Record of the Alternative Solution AL401959 regarding the tenant Louis Vuitton in the Fairmont Hotel at 900 W Georgia Street. Date range: January 1, 2013 to December 31, 2014.

ALTERNATIVE SOLUTION PROPOSAL

900 West Georgia Street, Vancouver September 24, 2014 (Rev Feb 26, 2015)

AL Number: **AL401959**

Fire Rated Glazing System
Sprinkler Locations - Conceptual Plan

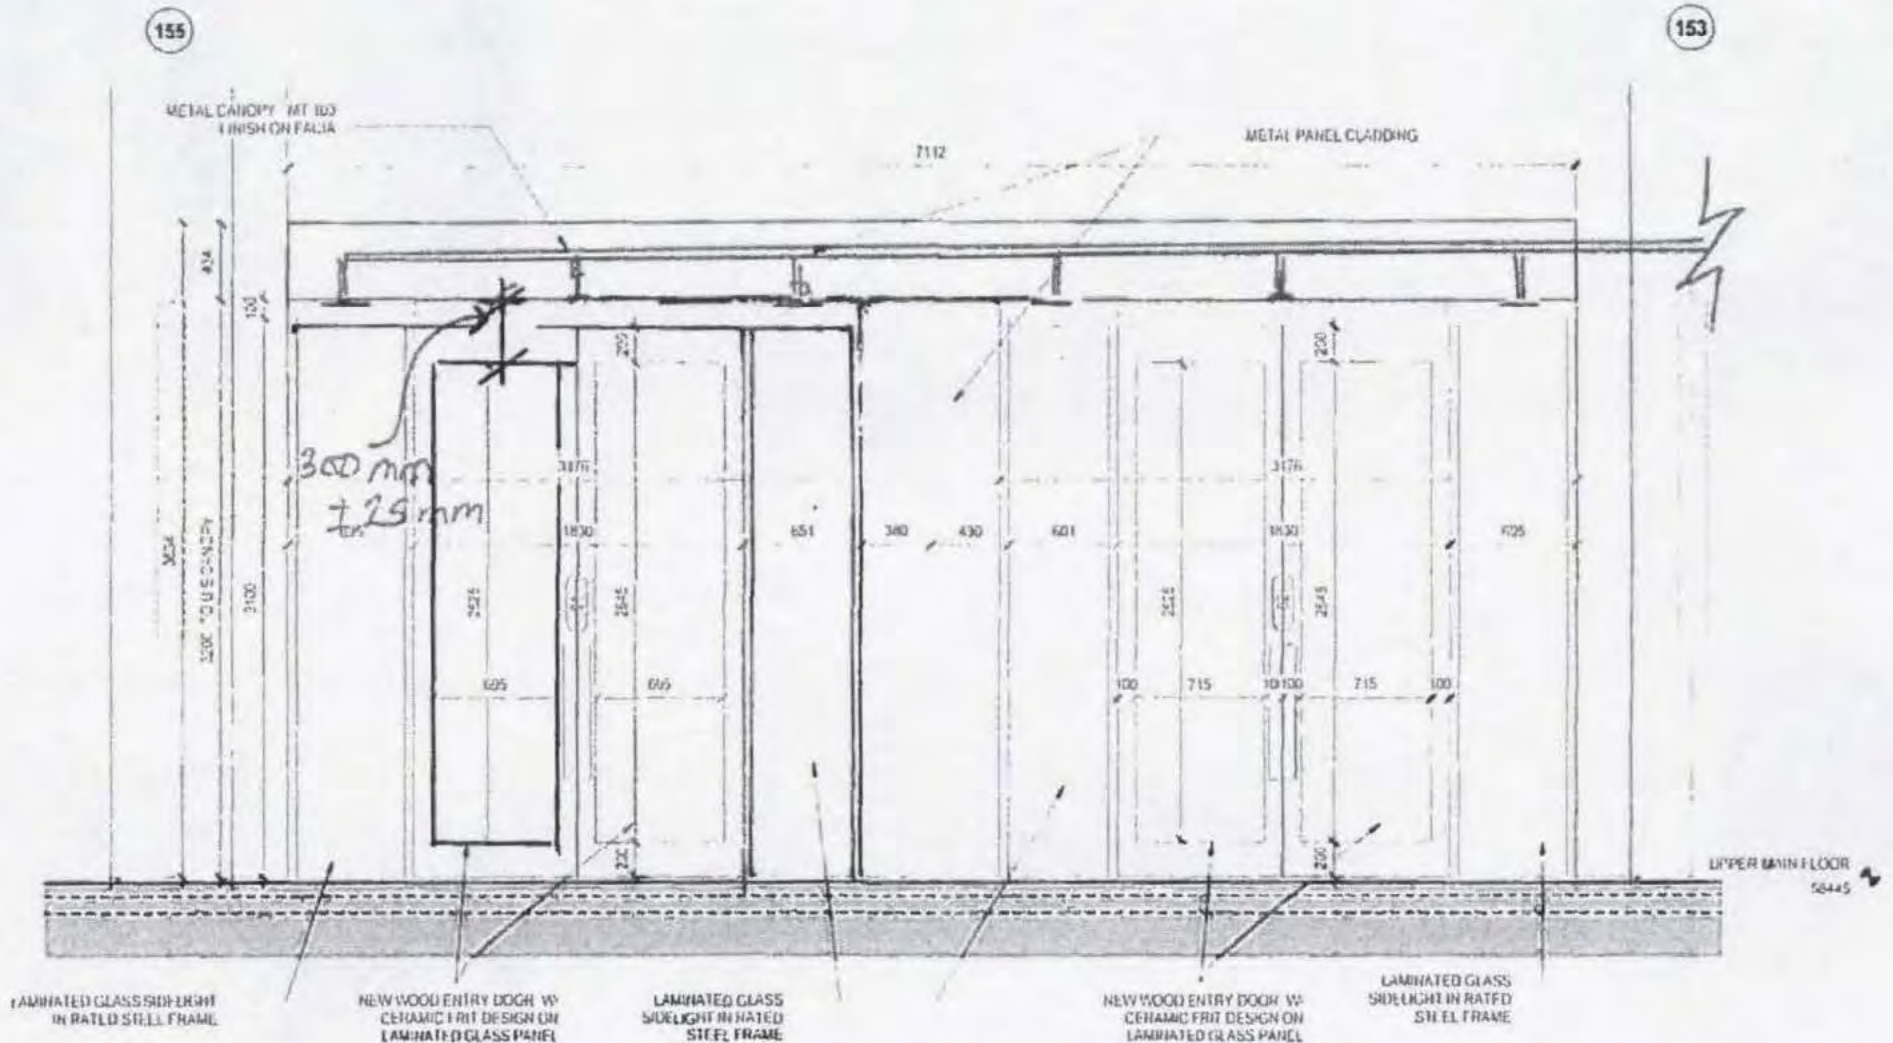
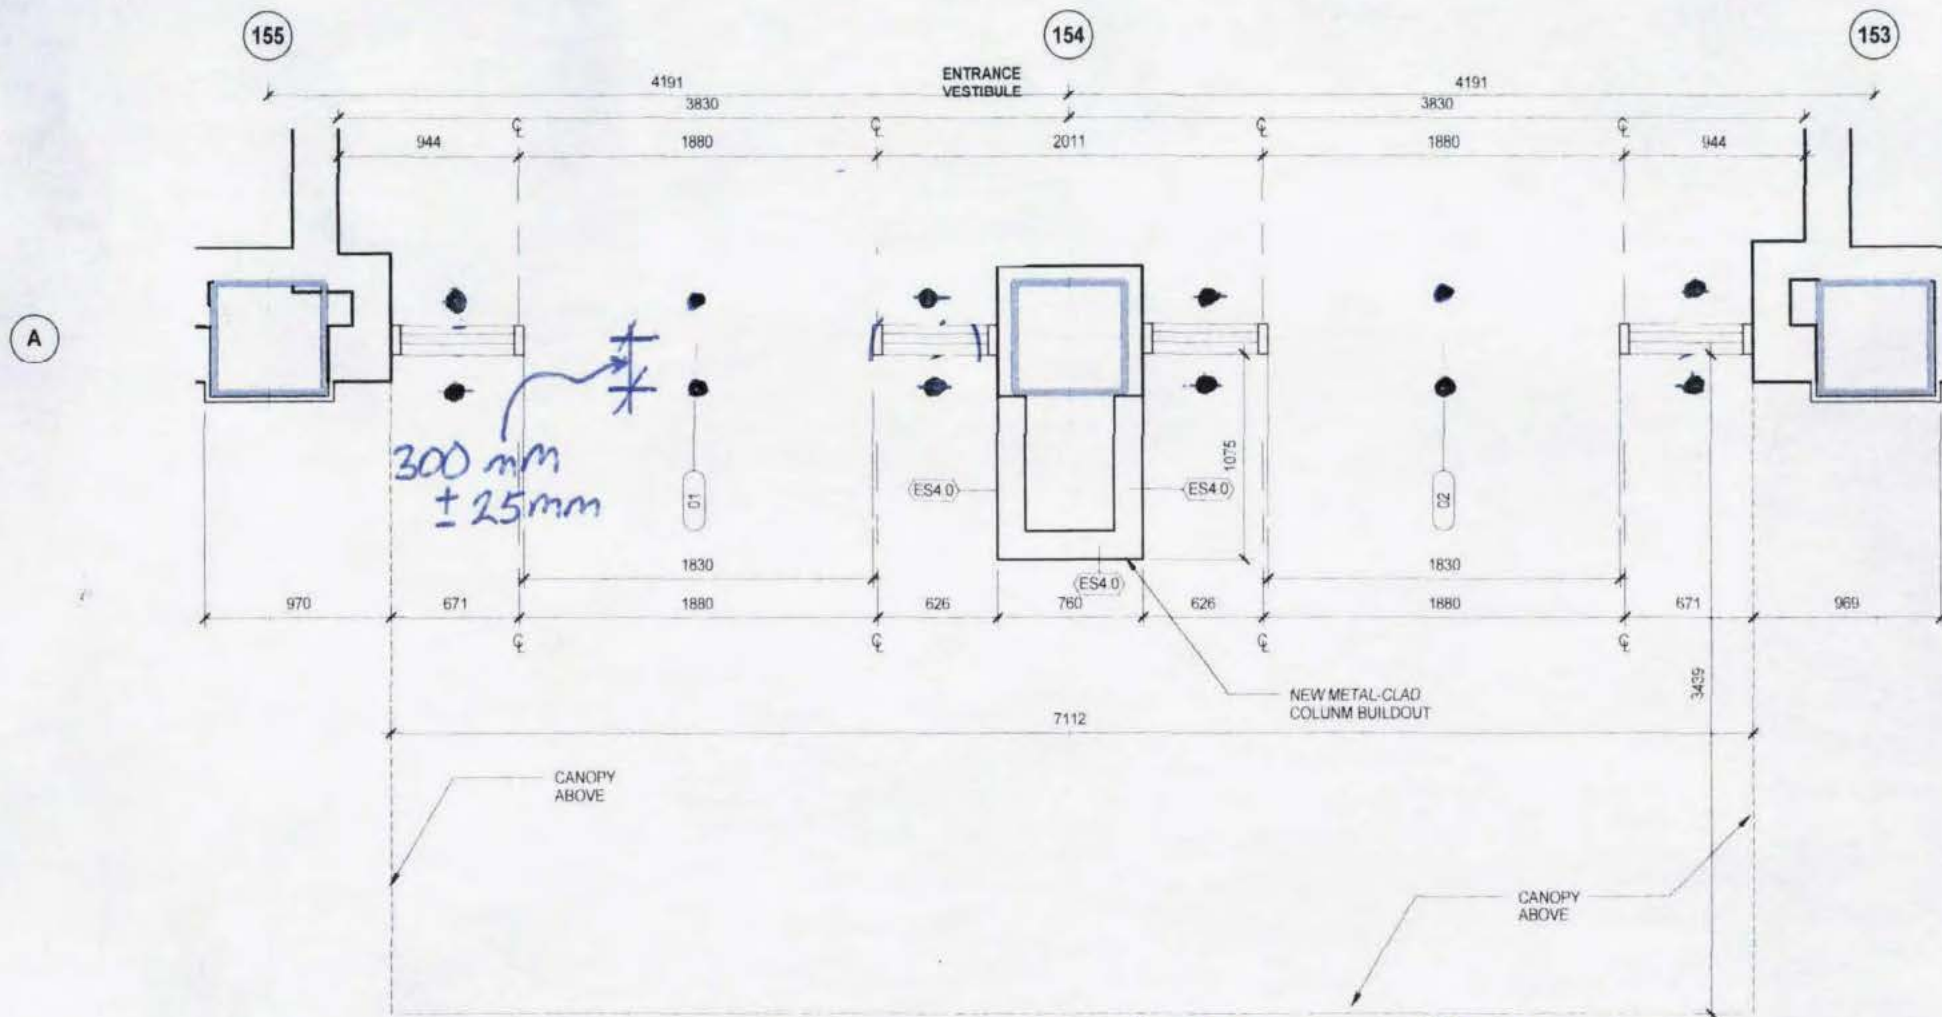
11. Sprinkler Piping Noncombustible (metallic) sprinkler piping.
12. Sprinkler Location Sprinklers are located on both sides of the door and fixed glazing system assemblies to be protected. Proximity of floor area sprinklers to be reviewed by sprinkler design engineer, and CFT Engineering Inc. on site.

13. Sprinkler Position Sprinklers protecting the doors and the fixed glazing to be pendant sprinklers and installed in accordance with the Construction Technology Update No. 12, and the sprinkler listing as follows:

- The pendent sprinklers for doors are to be located at the center of the door sets to be protected, approximately (± 25 mm) 300 mm horizontally away from the glazing surface, and (± 25 mm) 300 mm above the top of the door.

- Sprinklers for the fixed glazing will be located at the center of the fixed glazing panel to be protected, approximately (± 25 mm) 300 mm horizontally away from the glazing surface, and (± 25 mm) 300 mm above the top of the glazing.

Notes			
Number	Title	Included?	List seq Updated By Date Updated
 002	OFFICE OF THE CBO		002 B TURISHEV 09 Mar 2015
Oct 17, 2014. AL accepted after sketches were updated.			
Jan 15, 2015. Comments sent to CFT (dry sprinklers, sketches,			
scope of responsibilities discussions).			
Mar 09, 2015. Revised AL accepted.
